Wisconsin Department of Transportation

Proposal #22: 9995-03-60
City of Marinette, Lift Structure
Ogden Street Bridge, B-38-16
Menominee River 84.10
Local Street
Marinette County

This is Addendum No. 01, which provides for the following:

ADDENDUM NO. 1

ELECTRICAL PLAN & ELEVATION

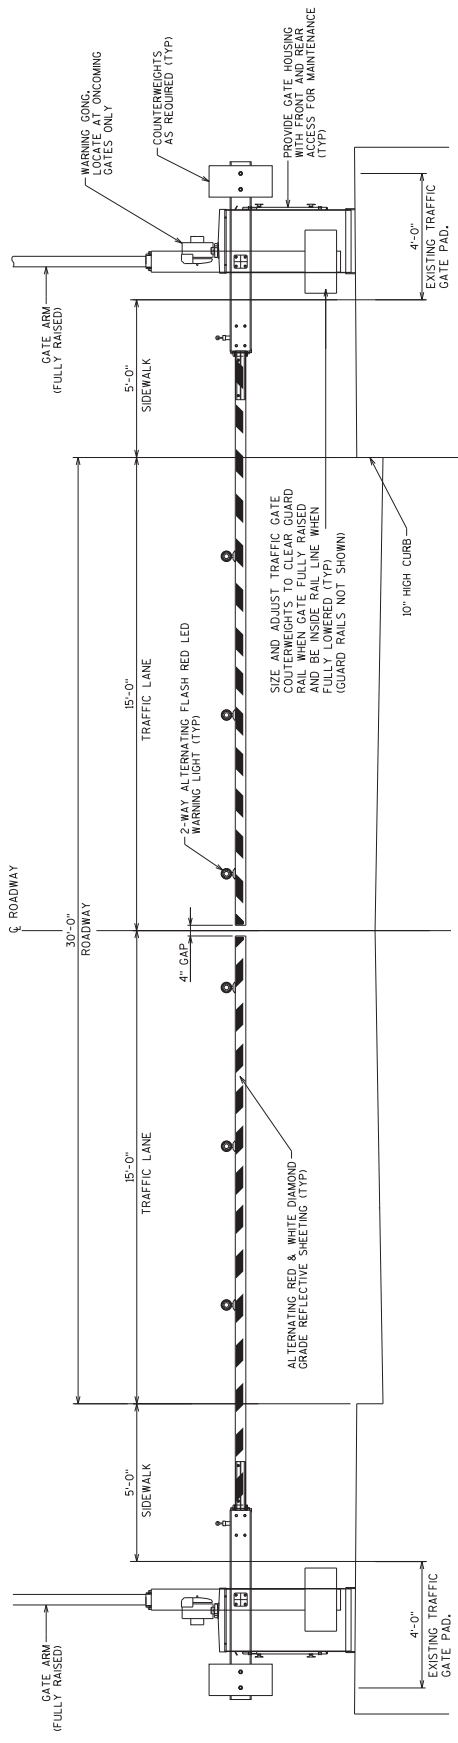
Revised Plan Sheets	
Plan Sheet	Plan Sheet Title (brief description of changes to sheet)
17	Electrical Demolition Plan E-1 – Removed Key Note for Limit Switch removal.
18	Electrical Plan and Elevation – Removed Key Note for Limit Switch Installation.
19	Electrical Details – Removed New Fully Closed Limit Switch detail
